Shearwater Teric Firmware Release Notes

VERSION 23 2022-12-21

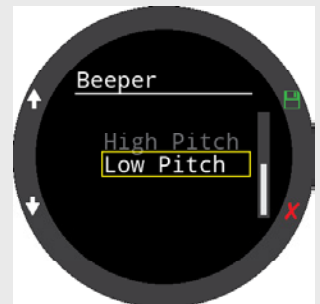
NEW Translated versions. Currently available for:

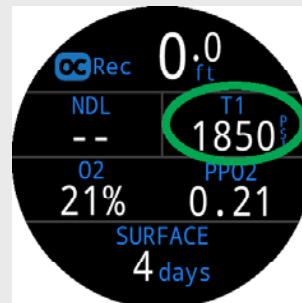
NEW Lower frequency option added for beeper, which may be easier for some users to hear.
